QUIKTRIP NO. 4245 SITE PLAN AND CONDITIONAL USE

3rd Submittal
 Comments in green were made by PW Engineering reviewer Sergio Um. Please reach out to him at sum@auroragov.org for any comments or questions.

COVER

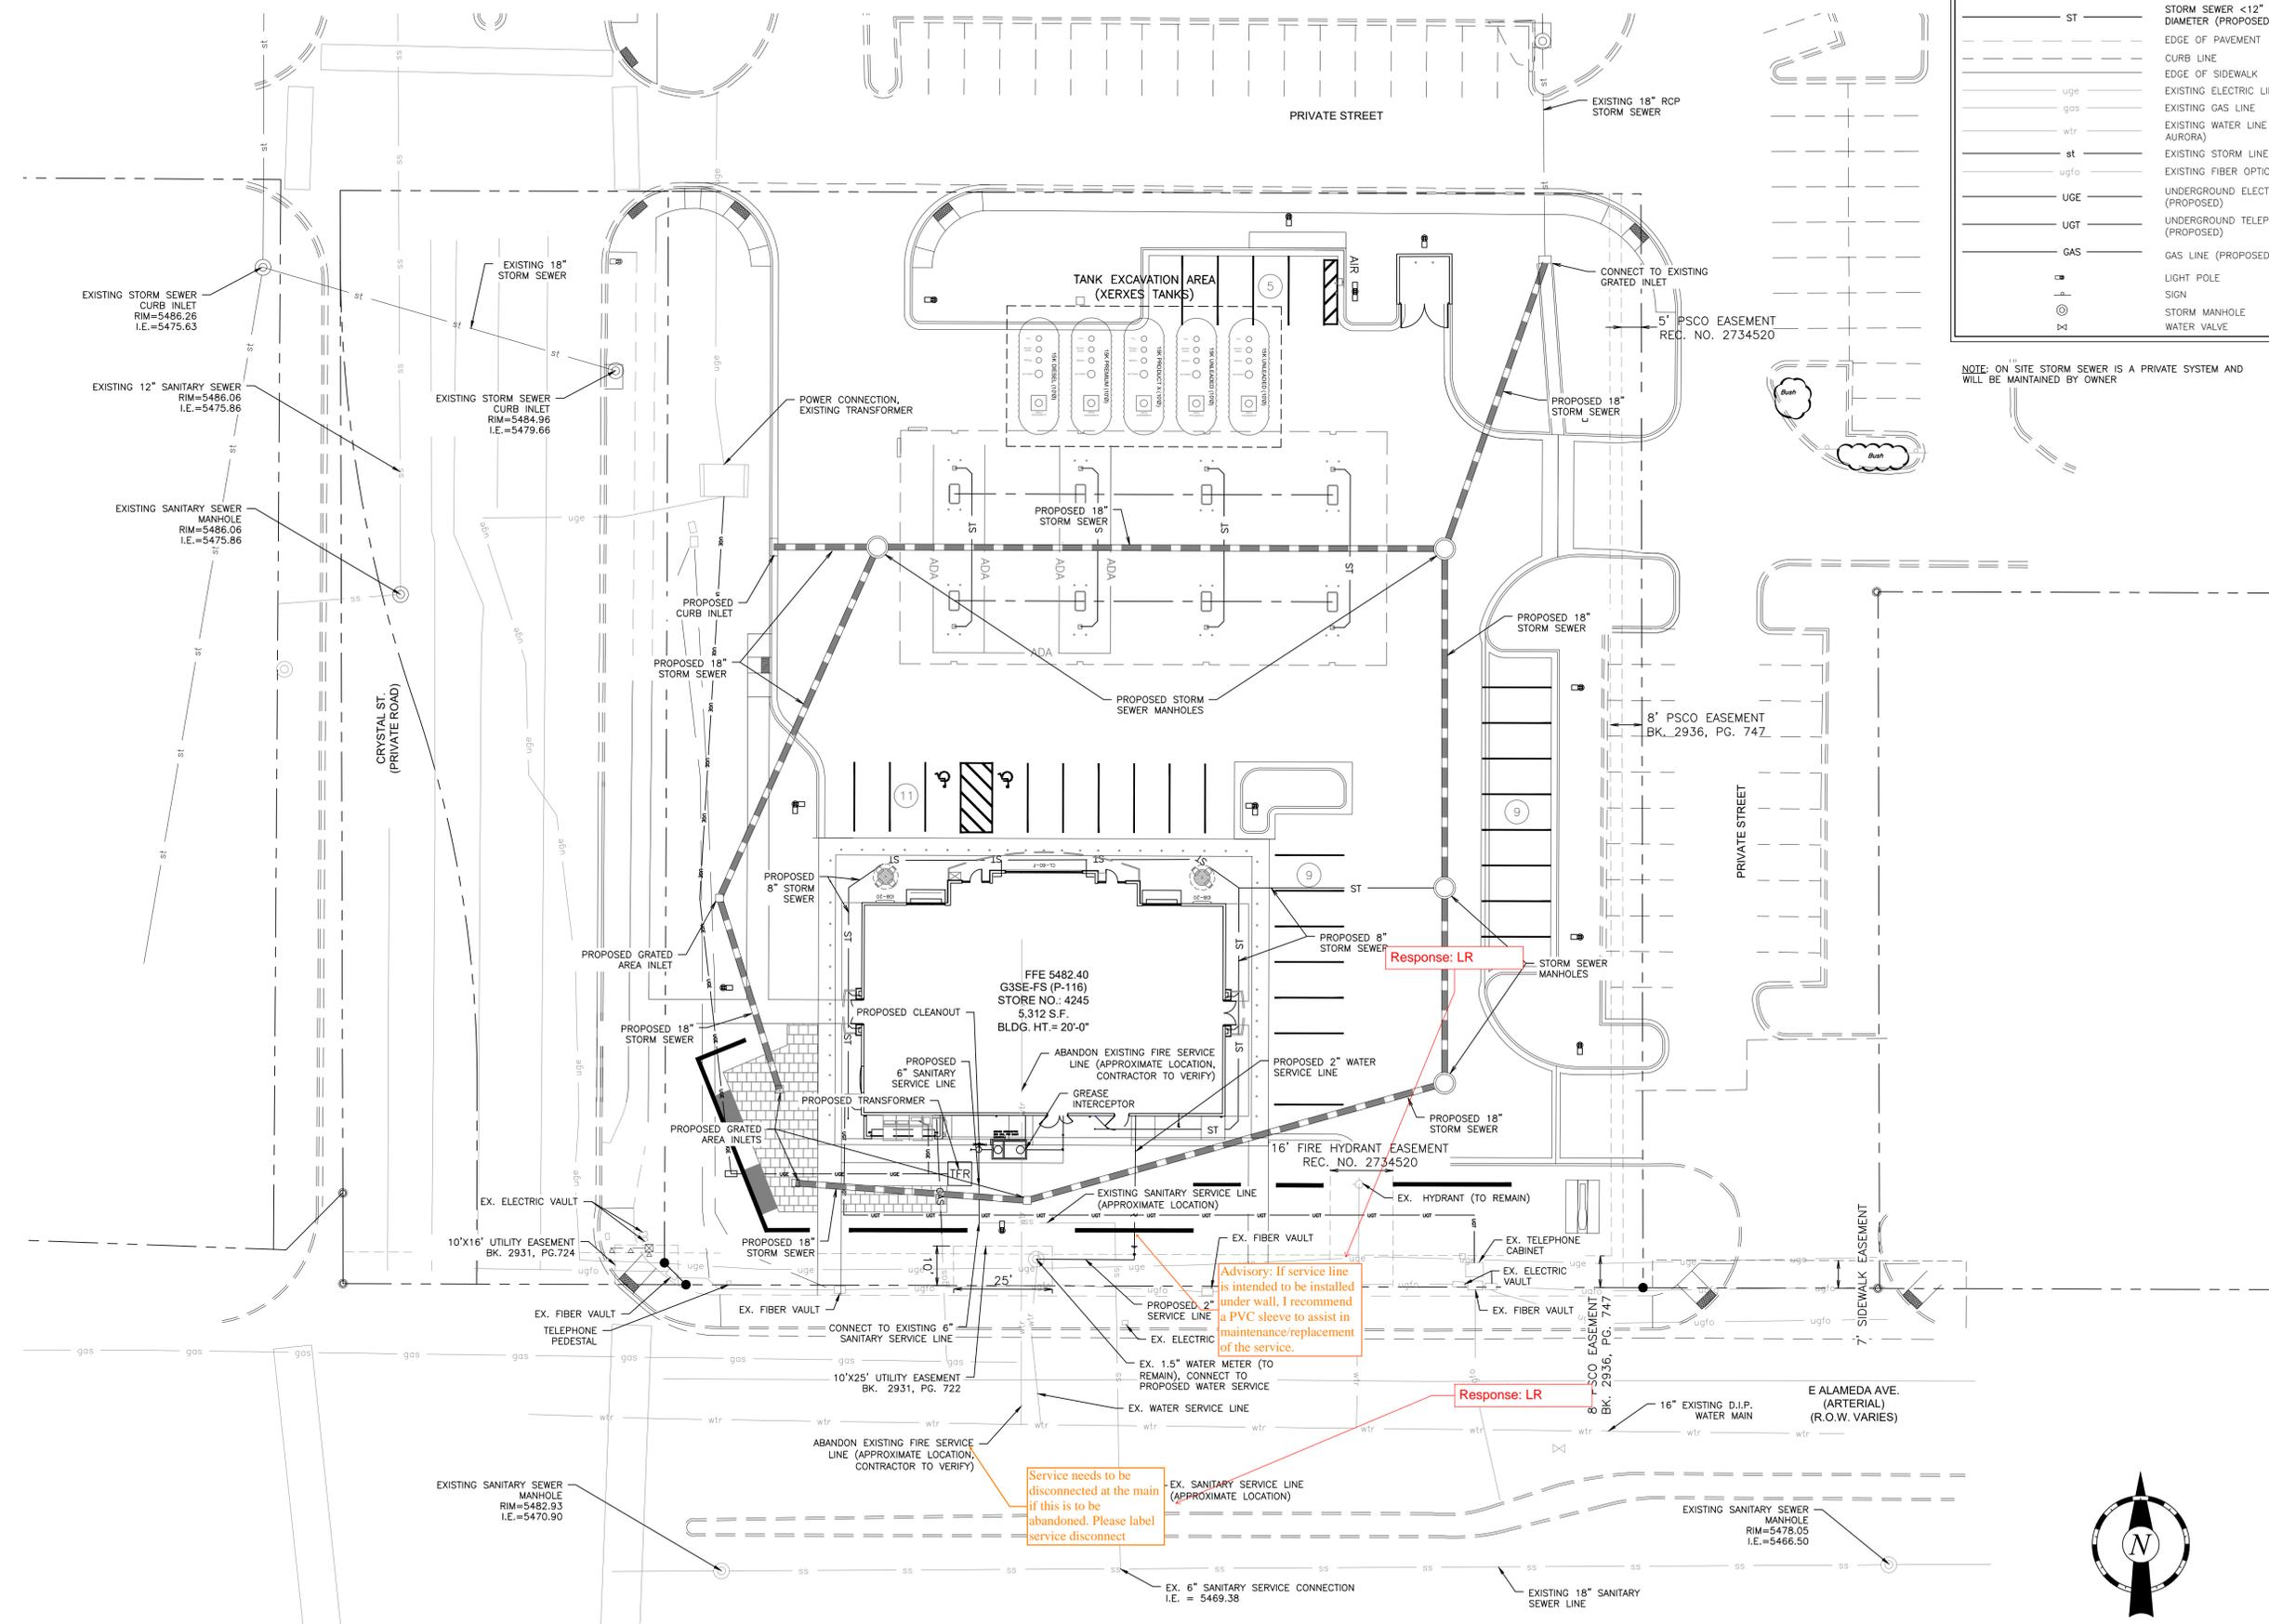
Advisory: If service line is intended to be installed under wall, I recommend a PVC sleeve to assist in maintenance/replacement of the service.

Service needs to be disconnected at the main if this is to be abandoned. Please label service disconnection.

Response: LR

Response: LR

SHEET TITLE:
PHOTOMETRIC

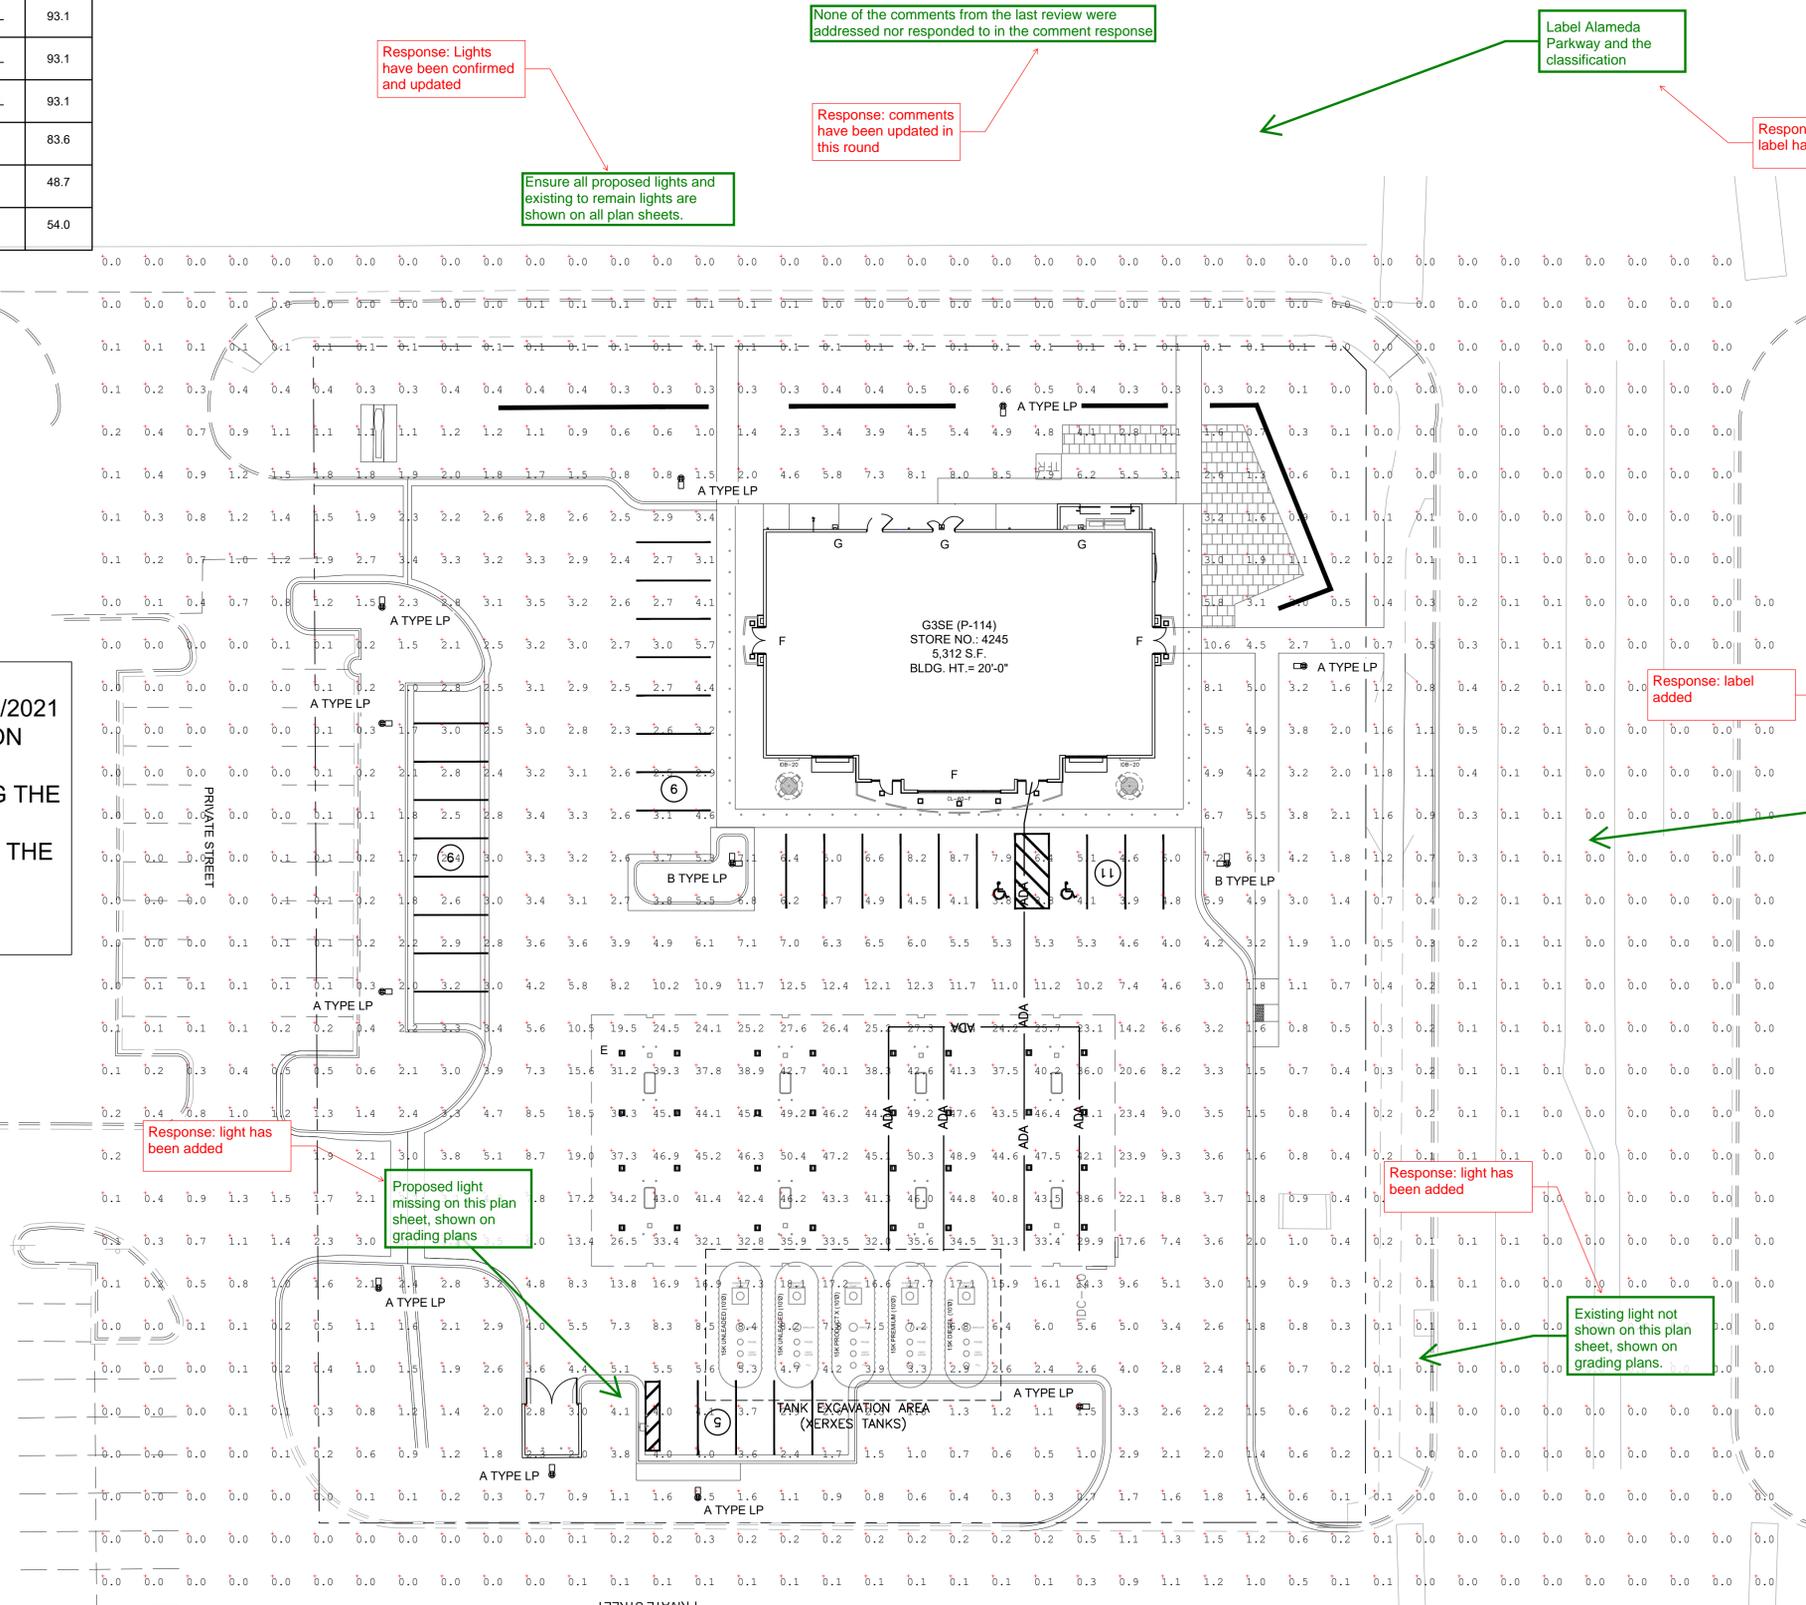
None of the comments from the last review were addressed nor responded to in the comment response

Ensure all proposed lights and existing to remain lights are shown on all plan sheets.

REPEATED COMMENT: Label Crystal St and the classification

REPEATED COMMENT: Fix orientation. North arrow shall point up to match the rest of the sheets.

Proposed light missing on this plan sheet, shown on grading plans

Existing light not shown on this plan sheet, shown on grading plans.

Response: Lights have been confirmed and updated

Response: comments have been updated in this round

Response: Alameda label has been added

Response: Note added

Response: north arrow changed to point to top of page

Response: light has been added

Response: light has been added
